APPLICANT: Madison Hills, LLC	PETITION NO:	Z-22
770-952-7047	HEARING DATE (PC):	08-03-10
REPRESENTATIVE: Margaret Stagmeier		
404-949-0180	PRESENT ZONING:	CF, OI, RM-12
TITLEHOLDER: Madison Hills, LLC		
	PROPOSED ZONING:	RM-12
PROPERTY LOCATION: Located on the south side of Delk Road,		
west of Bentley Road.	PROPOSED USE:	Apartments
ACCESS TO PROPERTY: Delk Road	SIZE OF TRACT:	37.574 acres
	DISTRICT:	17
PHYSICAL CHARACTERISTICS TO SITE: Existing apartments	LAND LOT(S):	799, 800, 856, 857
	PARCEL(S):	3
	TAXES: PAID X	DUE
CONTIGUOUS ZONING/DEVELOPMENT	COMMISSION DISTRIC	CT:

APPLICANT: Madison	n Hills, LLC	PETITION NO.:	Z-22
PRESENT ZONING:	DI, CF, RM-12	PETITION FOR:	RM-12
* * * * * * * * * * * * * * * * * *	* * * * * * * * * * * * * * * * *	* * * * * * * * * * * * * * * * *	* * * * * * * * *
ZONING COMMENTS:	Staff Member Responsib	ole: John P. Pederson, AICF)
Land Use Plan Recommenda	tion: High Density Reside	ntial (5-12 units per acre)	
Proposed Number of Units:	446 Overal	ll Density: 11.86	Units/Acre

DRAINAGE COMMENTS

STAFF RECOMMENDATIONS

Z-22

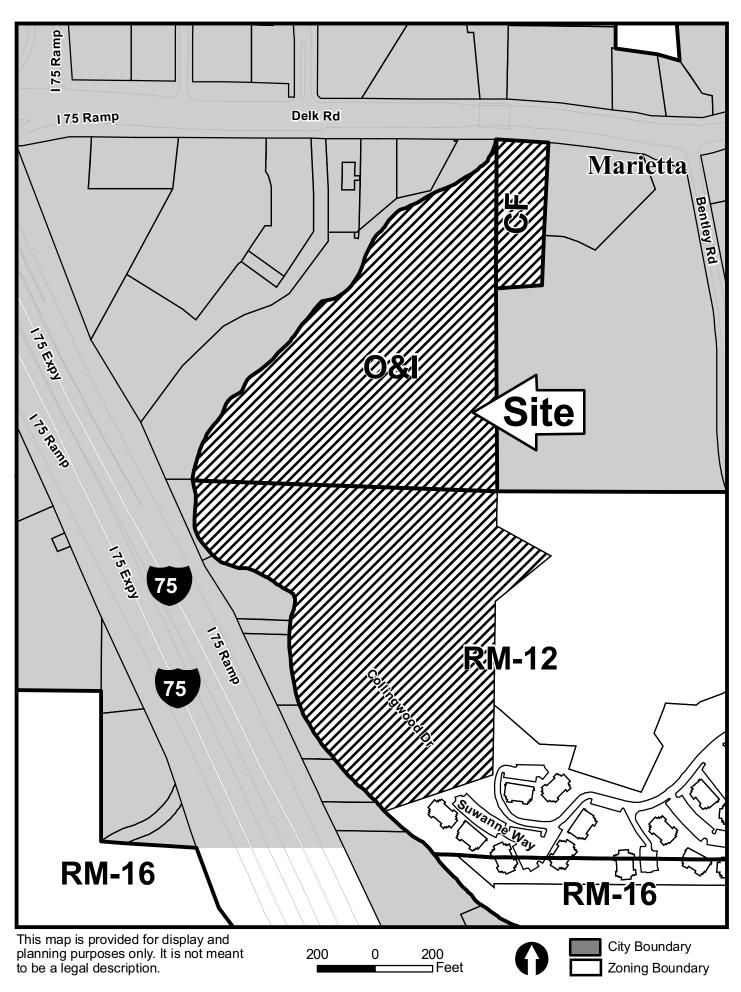
- Provide comprehensive hydrology/stormwater controls to include development of out parcels.
- Submit all proposed site improvements to Plan Review.
- Any **spring activity** uncovered must be addressed by a qualified geotechnical engineer (PE).
- Structural fill _____ must be placed under the direction of a qualified registered Georgia geotechnical engineer (PE).
- \boxtimes Existing facility.
- Project must comply with the Water Quality requirements of the CWA-NPDES-NPS Permit and County Water Quality Ordinance.
- Water Quality/Quantity contributions of the existing lake/pond on site must be continued as baseline conditions into proposed project.
- Calculate and provide % impervious of project site.
- Revisit design; reduce pavement area to reduce runoff and pollution.

- No Stormwater controls shown
- Copy of survey is not current Additional comments may be forthcoming when current site conditions are exposed.
- No site improvements showing on exhibit.

- Site plan received by the Zoning Division June 6, 2010, with the District Commissioner approving minor modifications;
- Stormwater Management comments and recommendations; and
- DOT comments and recommendations.
